VILLAGE OF CALEDONIA UTILITY DISTRICT MEETING AGENDA

RE: Storm Sewer Reroute & Watermain Extension Plan – Conditional Approval – Central Storage & Warehouse LLC

RE: Storm Water Management Plan & Storm Water Pond Plan –
Conditional Approval – Gifford School Parking Lot

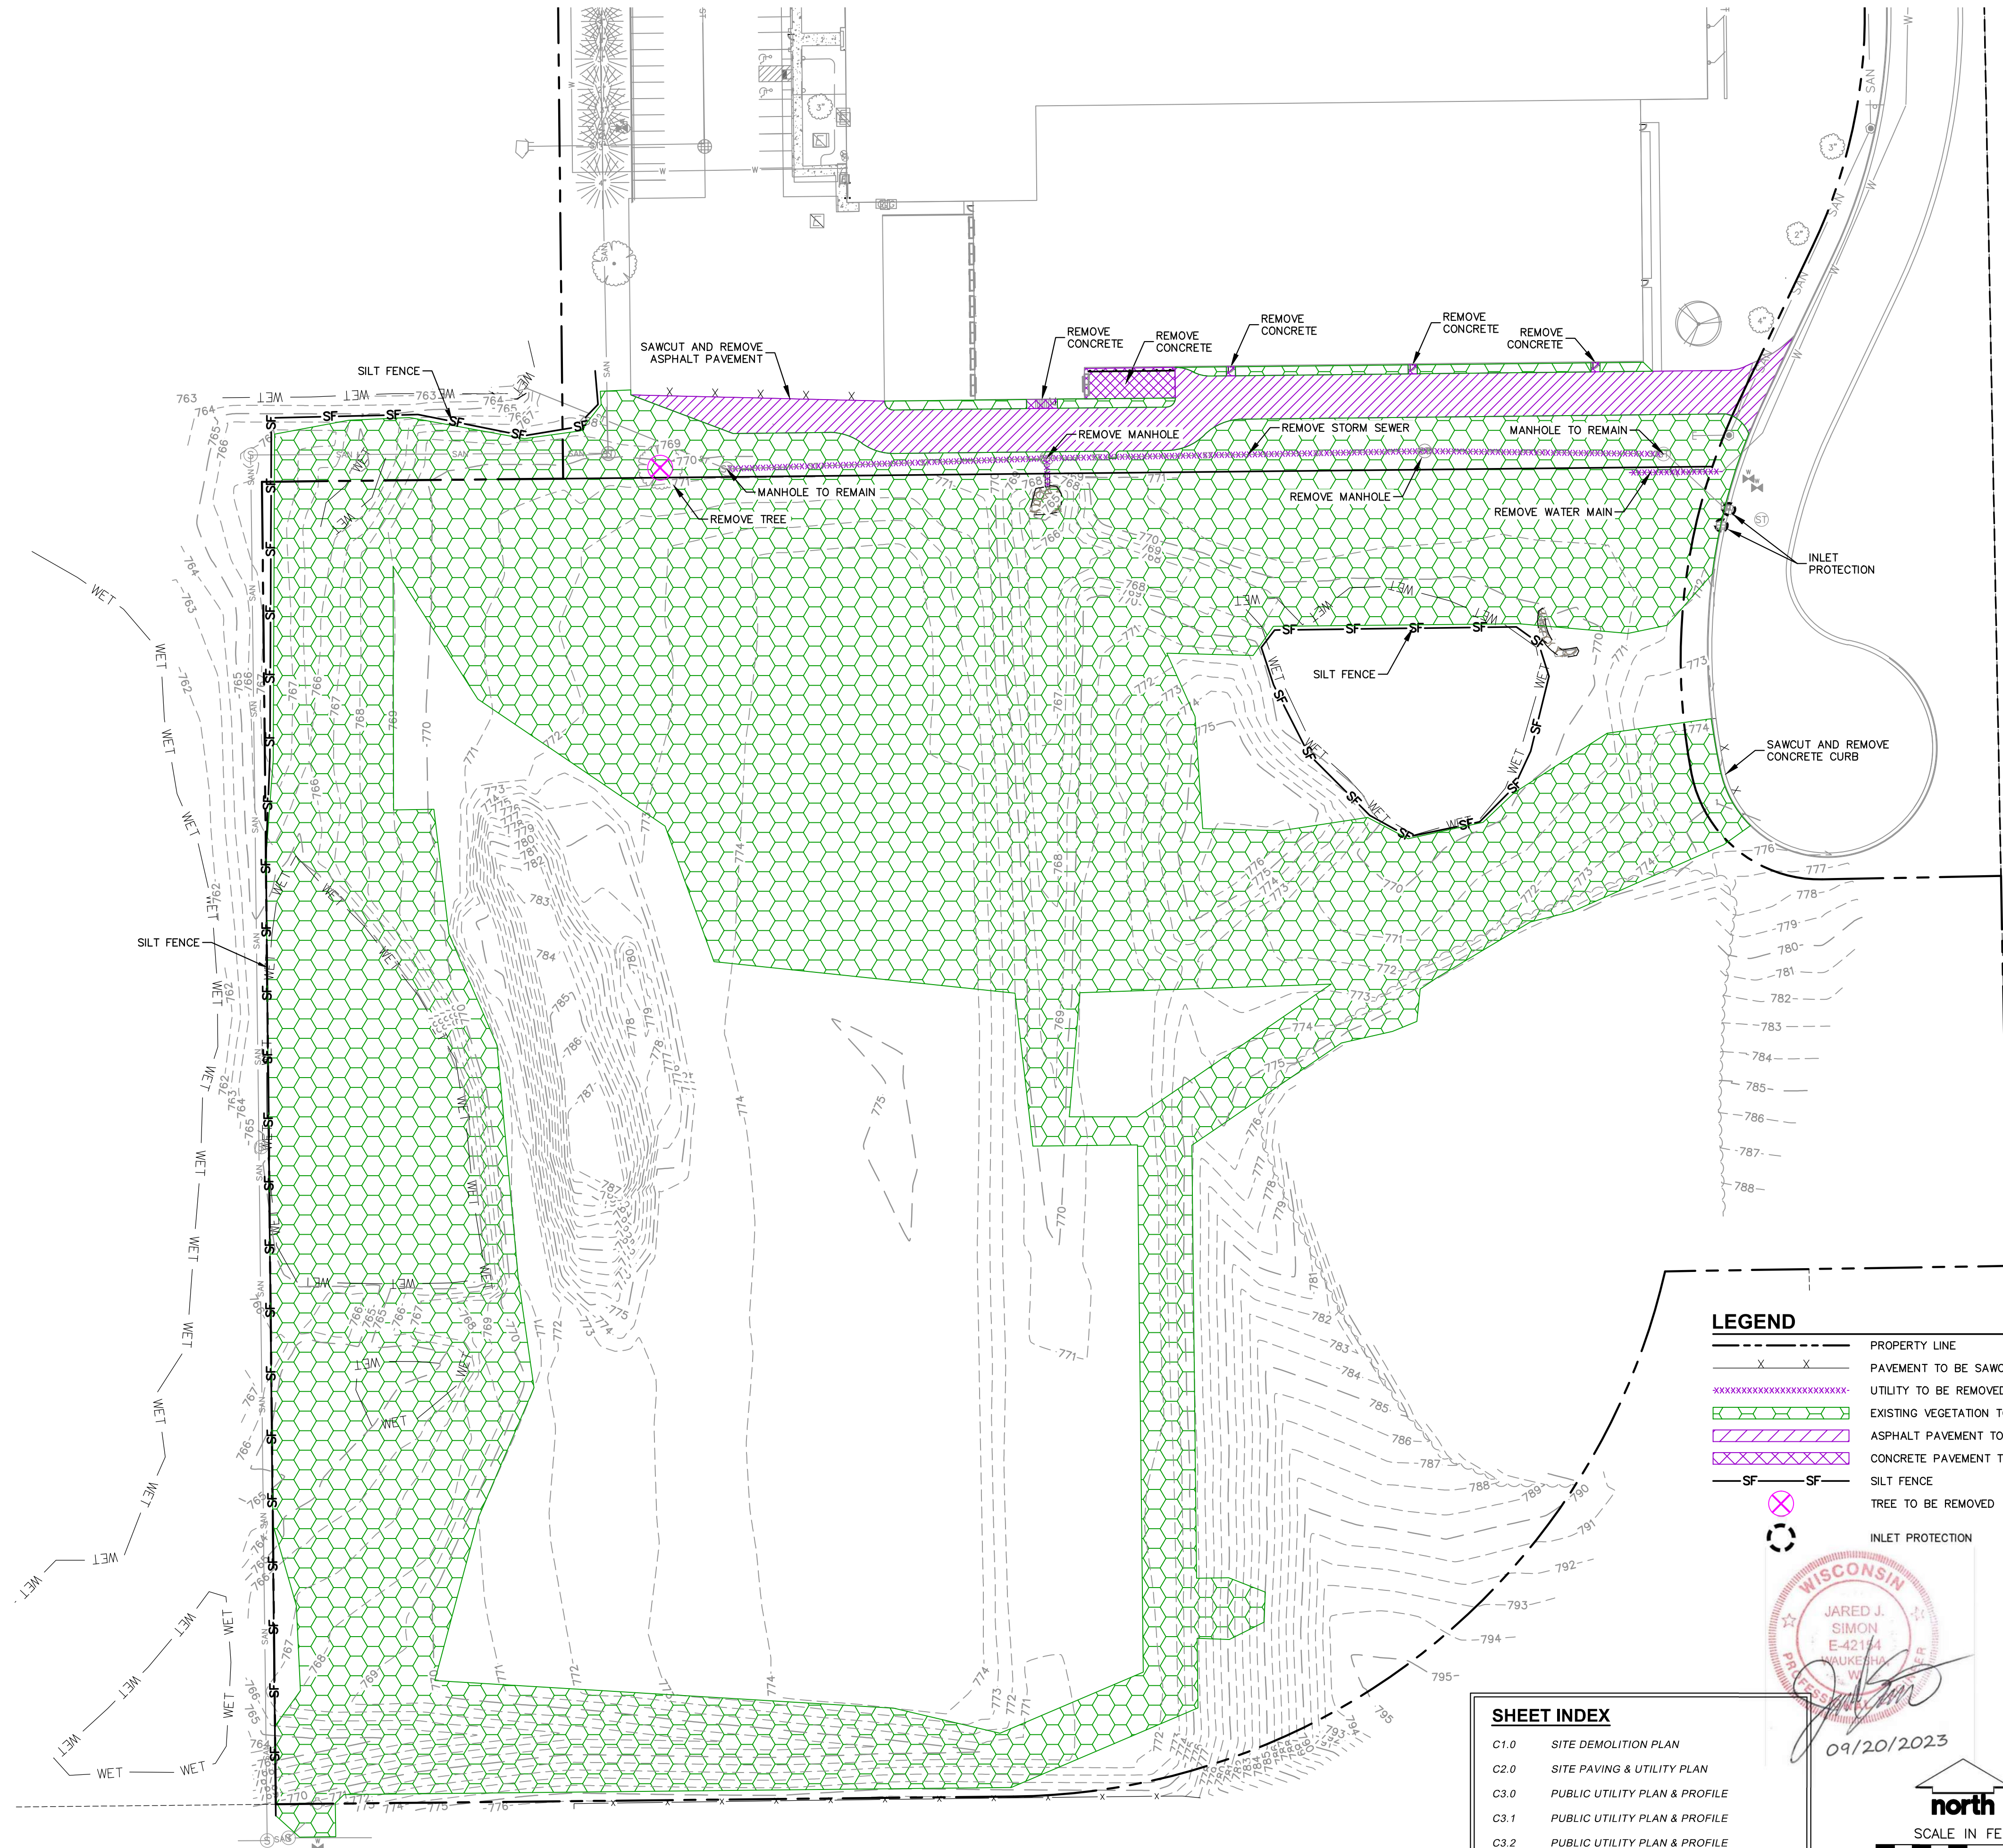
The Storm Sewer Plans have also been reviewed by staff but require some clarification prior to final approval. The current proposed storm sewer has been upsized to accommodate the flow from the East due to the change in slope and capacity but does not appear to have been sized to accommodate any flow from the proposed building. This clarification is required to ensure that the appropriately sized storm sewer is installed at this time.

Move to conditionally approve the Storm Sewer Reroute & Watermain Extension Plan subject to the following condition:

EROSION CONTROL PLAN

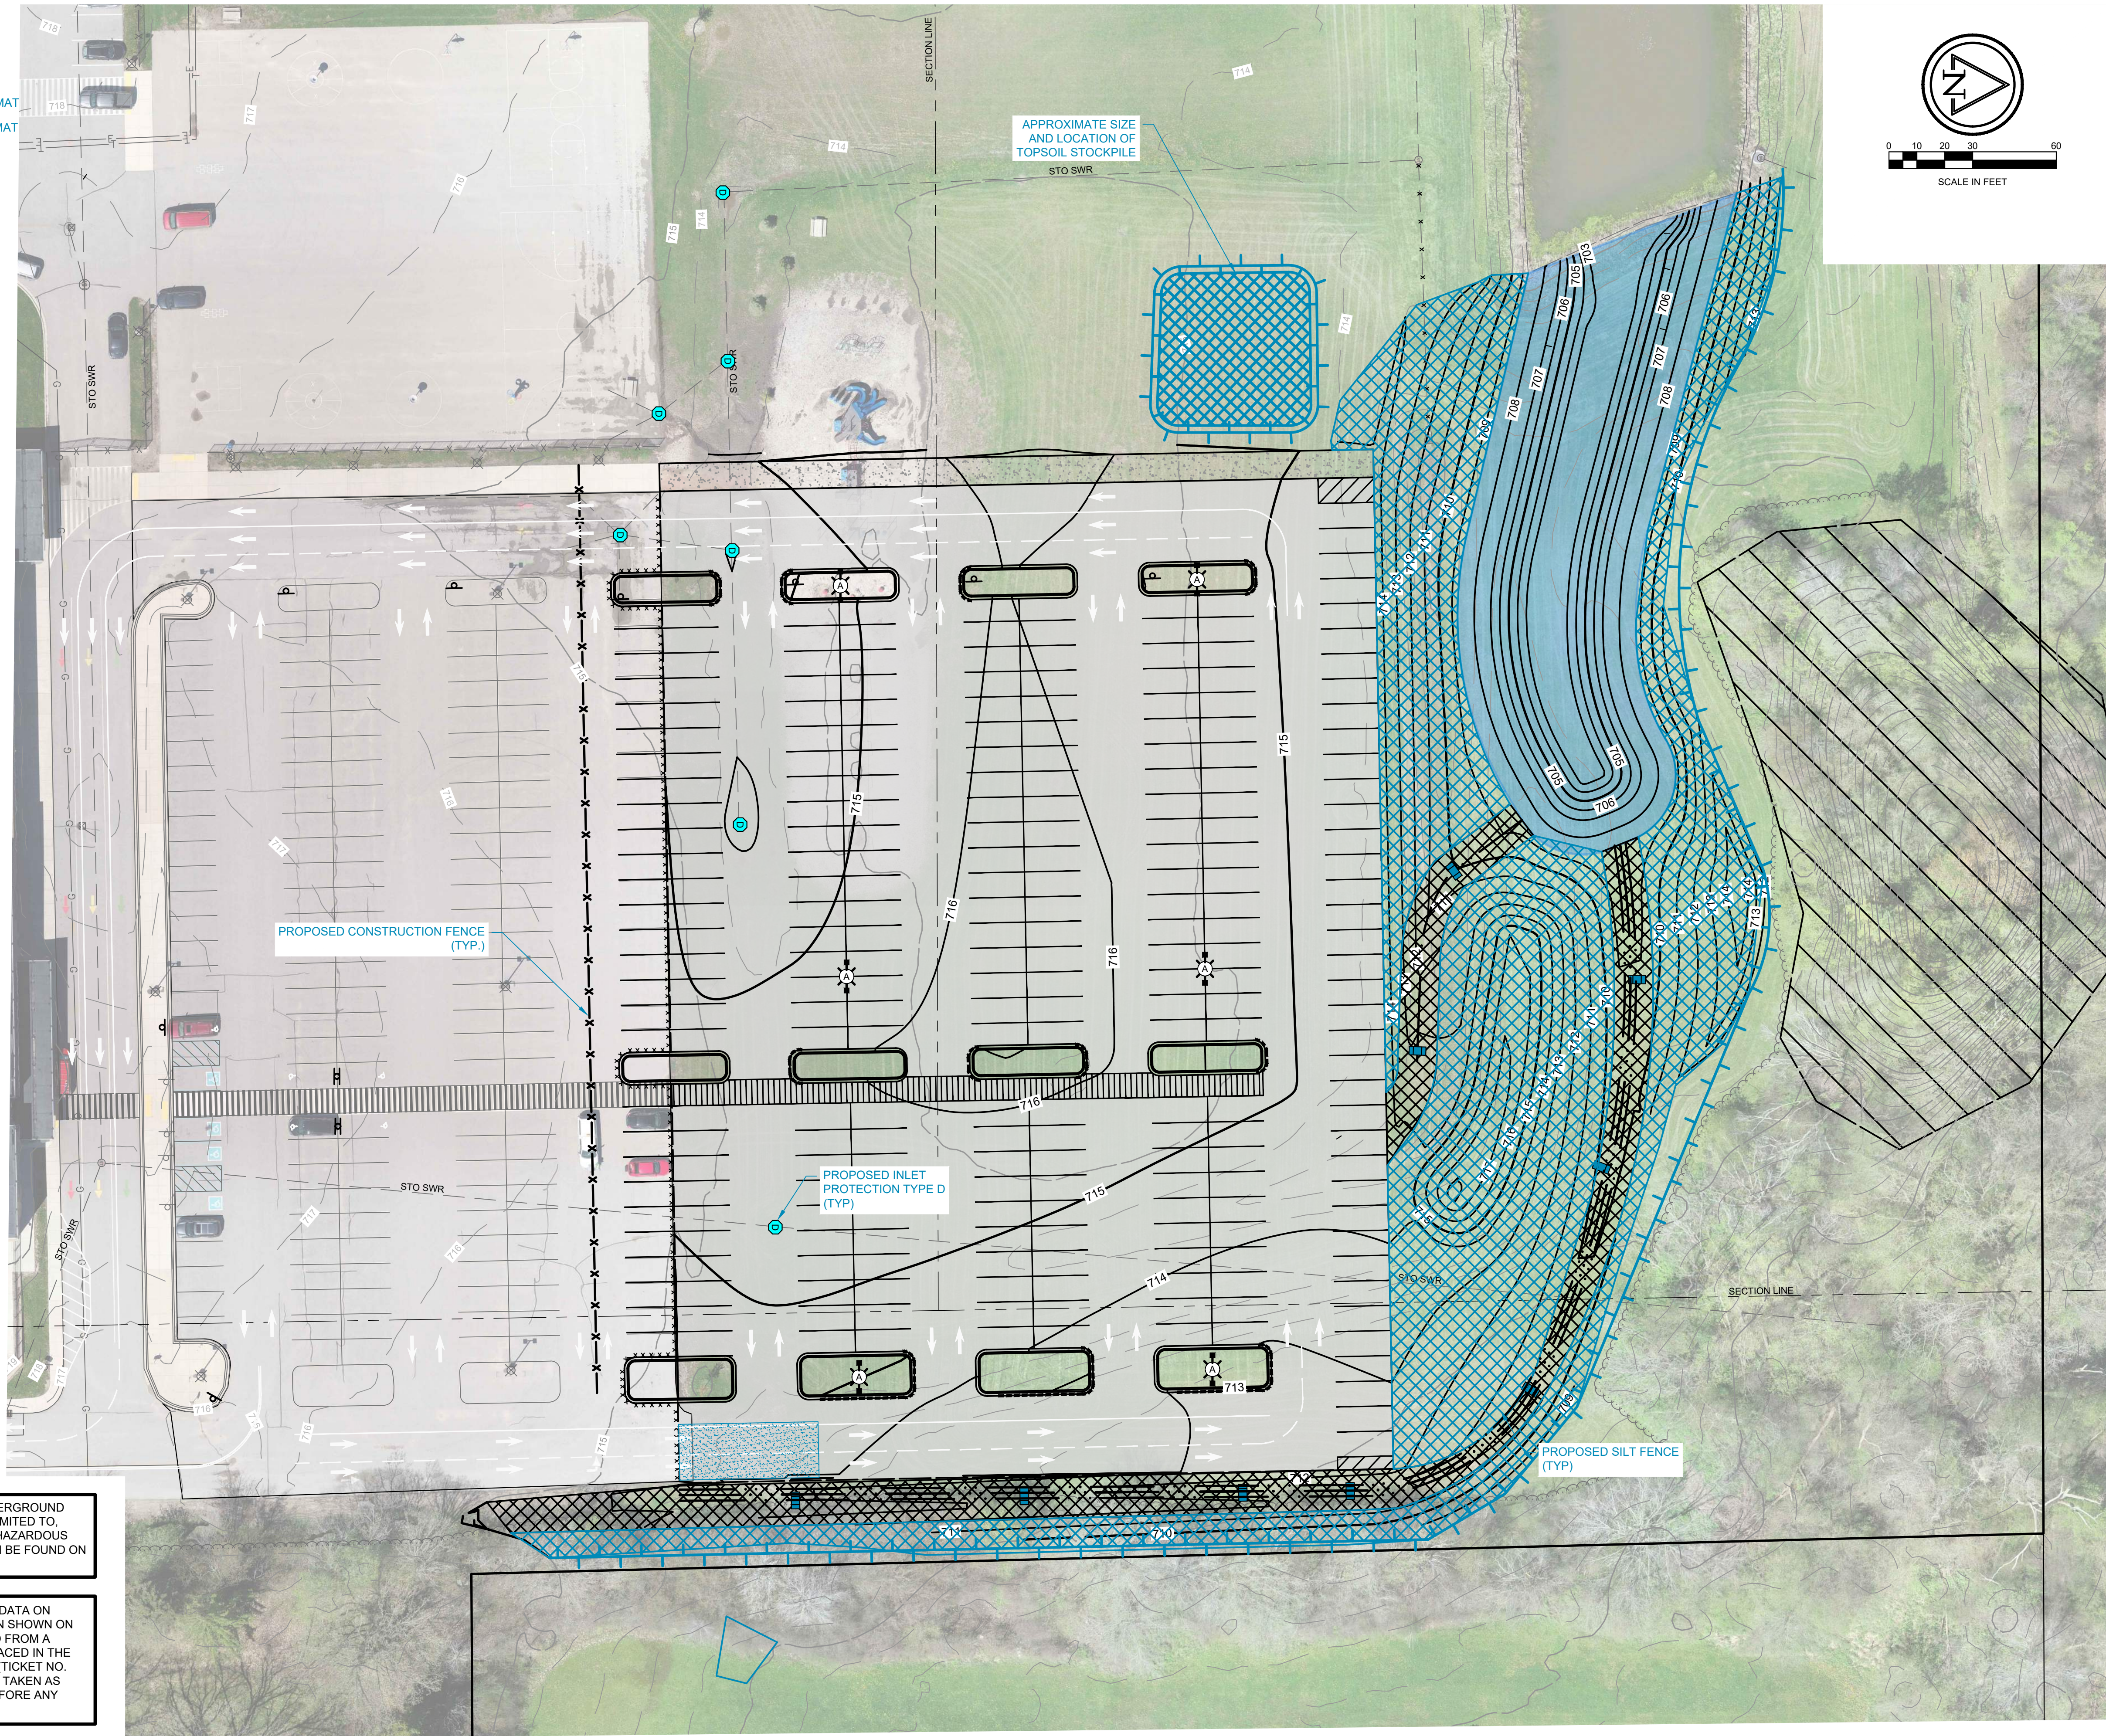
The Storm Water Pond Plan has been reviewed by the Village Engineer and the Public Services Director. There are some minor revisions requested to ensure that the drainage is contained within the storm water pond and drainage swale and that the 10' safety shelf is installed on the expansion of the pond.

- The grading plan does not have the 707 and 708 contours 10' apart for the 10' safety shelf.
- The 100-year water surface elevation in the pond is 710.84 and the plugged 100-year water surface elevation in the pond is 712.06. Due to the swale draining to the storm water pond being lower than the pond berm it may be used as storage, but the top of bank on the swale must be a minimum of 712.50 to match the top of bank on the storm water pond. Due to the swale being lower and the swale top of bank lower than the top of berm in the Northeast corner of the site, the runoff will bypass the storm water pond in the 100-year event.
